ADDENDUM #1

Bid No. 20-83-5212

For: To provide all materials, equipment, and labor for the replacement of a portion of the Big Creek Greenway, from McFarland Road Trailhead to Union Hill, approximately 1.810 miles.

TYPICAL SECTION 1 - BOARDWALK REPLACEMENT
FOR ADDITIONAL DETAILS SEE 35-SERIES

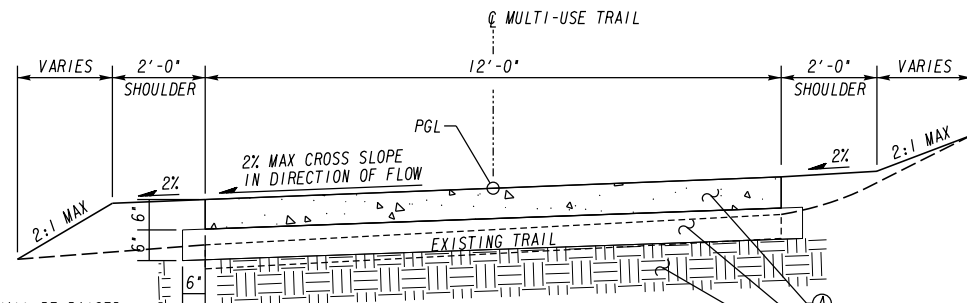
1. The typical boardwalk section #1 on sheet 05-0001 notes boardwalks 1-6 are to have steel caps. Sheet 35-0002 Indicates steel caps are an option in reusing existing piles yet the section drawing notes for new or existing. Please clarify/ quantify the amount of steel caps to be used on each boardwalk. *Boardwalks 1-6 are to have steel caps as noted on the plans. The option for wooden caps as indicated on sheet 35-0002 are only in locations where new boardwalk is proposed (not replaced) outside of the sewer line easement.*

TYPICAL SILT FENCE PLACEMENT

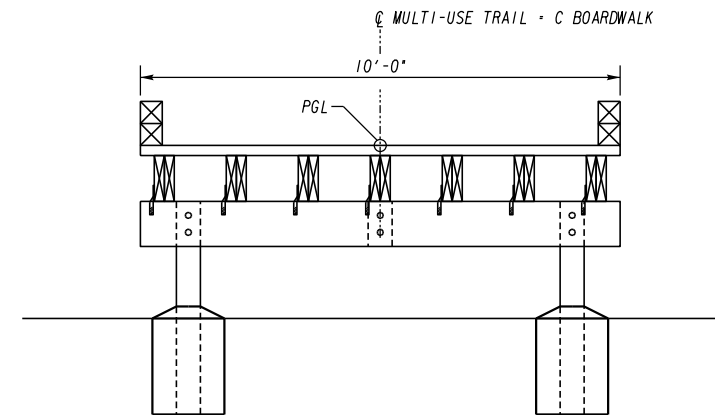
13. - Will the silt fence be required to be installed in the areas where the boardwalk will be rebuilt? The specs call for top down construction methods to be used, and the installation of trenched in silt fence will create a significant amount of disturbance. *Silt fence may be omitted at boardwalks 1-6 where all work is required to be performed from the top of*

20. - On sheet 04-0001, note 6 states that the boardwalks will be built using top down construction, and no equipment will be allowed in the wetlands. Will type C be required for the length as it appears, or will be it be installed judiciously at the direction of the project manager? *Yes, type C silt fence is required for the length as shown on the detail on drawing 05-0001.*

NOTE: SILT FENCE MAY BE OMITTED AT BOARDWALKS 1-6 WHERE ALL WORK IS
REQUIRED TO BE PERFORMED FROM THE TOP OF BOARDWALK. THE CONTRACTOR SHALL
BE RESPONSIBLE FOR MAINTAINING SEDIMENT WITHIN THE ENTIRETY OF THE WORK
ZONES AND SILT FENCE IS REQUIRED IN ALL AREAS OF GROUND DISTURBANCE.

SUBSTRUCTURE REHAB OPTION 1 - WOOD CAP
TO BE USED IN ALL NEW CONSTRUCTION

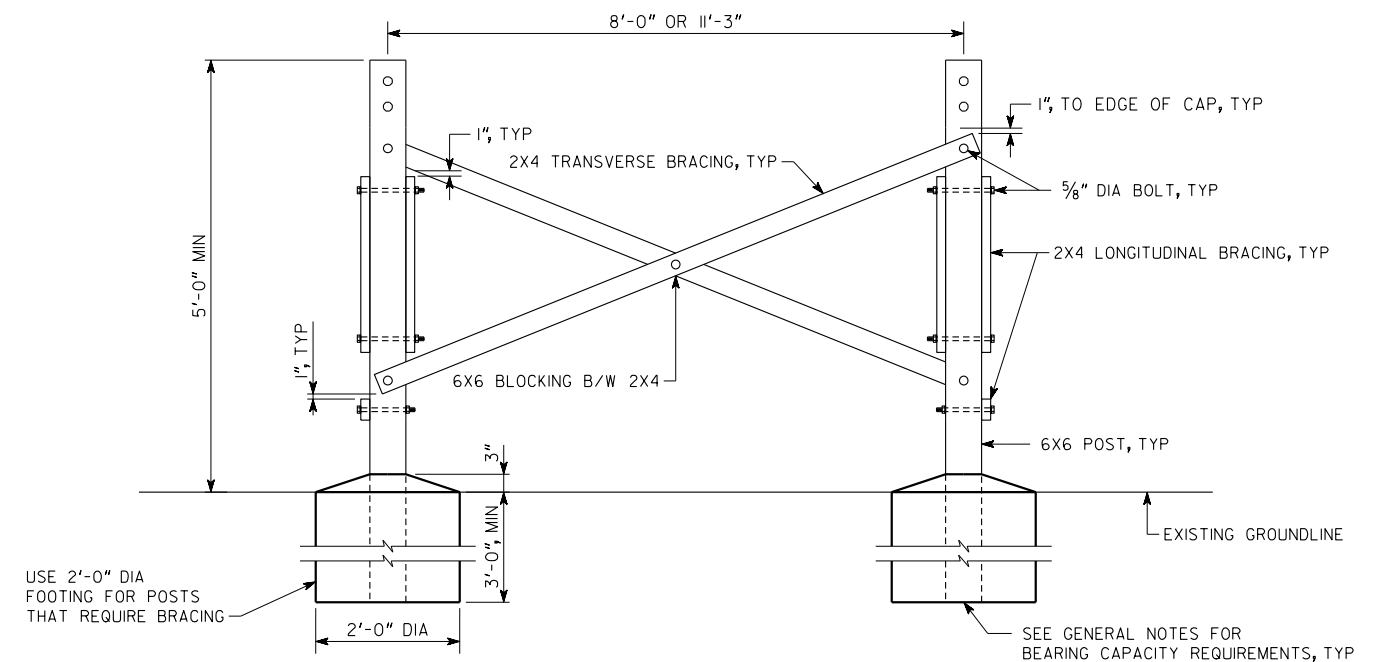
11. - On the pile caps, can you confirm the correct use of options 1 and 2? Can option 1 be used for all caps, or is it only for new posts? Is steel required for the reuse of all existing posts? *Option 1 is allowable (and desired) for boardwalks 5A, 8 and 9. The others (1-6) must use Option 2. This is due to the exiting sewer line running along and under the existing boardwalks 1-6. A wooden cap is not viable where the posts are spaced 12' apart as existing to avoid sewer line relocations. Any post that are replaced shall be replaced in the same location as existing.*

19. - On sheet 35-0002, there are two details for the pile caps. Option 1 says for all new construction, while option 2 says for reused posts. Would the county consider as an alternate the exclusive use of the timber caps? If so, could there be an alternate consideration for a solid beam cap? *Option 1 is for locations where the existing posts much be reused at their 12' wide spacing in order to avoid conflicts with the existing sanitary sewer line. A timber cap is not structurally sufficient for the reuse of the existing posts. Option 2 is acceptable for all other locations as shown and noted in the plans.*

2. Steel caps in large quantities will be expensive. Will 3 x 12 wood caps for all boardwalks be an acceptable substitution? *Wood caps are only allowable on boardwalks on new locations (boardwalks 5A, 8 and 9) as shown on the plans. In all other areas steel caps are required.*
